1175 Clark Fork Ln.
Revised Scope of Work
By the City and County of Missoula
Project previously quoted by Grizzly Fence

Part 2 of the revised quote for
fencing at 1175 Clark Fork LN.

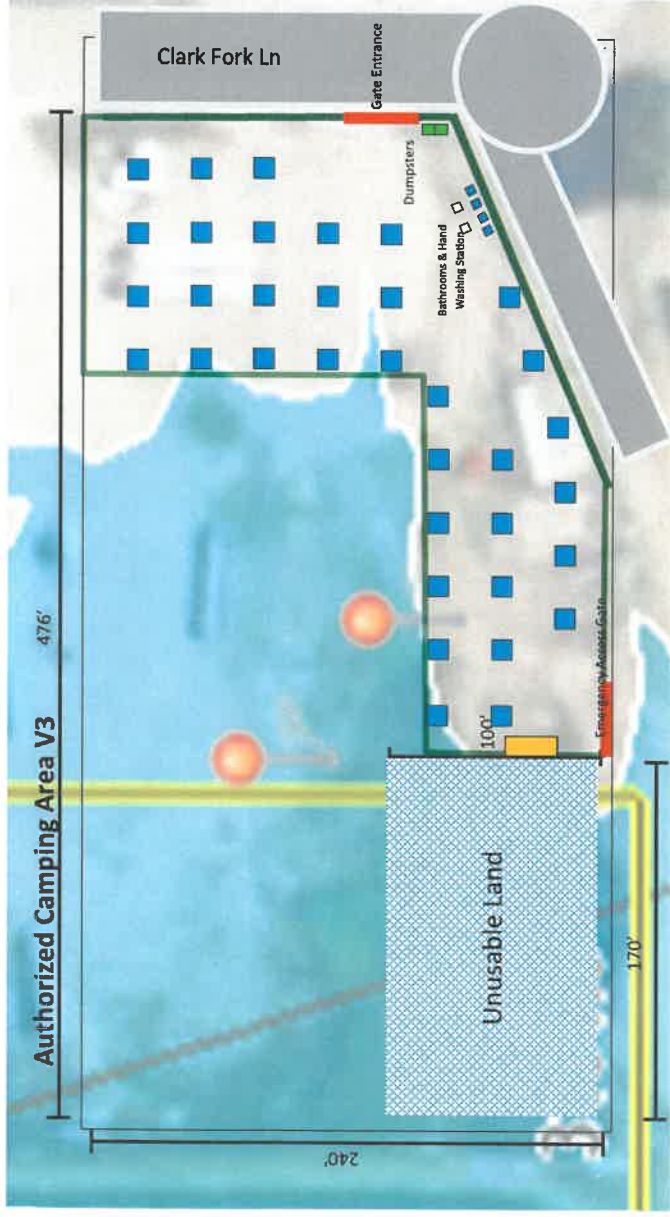
- From the point on the previous bid that we agreed to put a gate, install rolling gate to cross the 30' of road leading into the Compost Facility. 6' tall with 3 row barb wire.
- Gate needs to swing West away from Clark Fork Ln.
- Also needs to tie in with new fence being installed by your team for the 1175 Clark Fork Ln. property along the South side fencing. Right where the permanent fence turns into temporary fence.
- From new gate on the South side of the road leading into the Facility, run 75' of permanent 6' fence with 3 row barb wire to the existing green gate leading into the Compost Facility.
- On the other side of the existing green gate, repair/replace the 43' of existing 6' fence top rail and add 3 row barb wire.
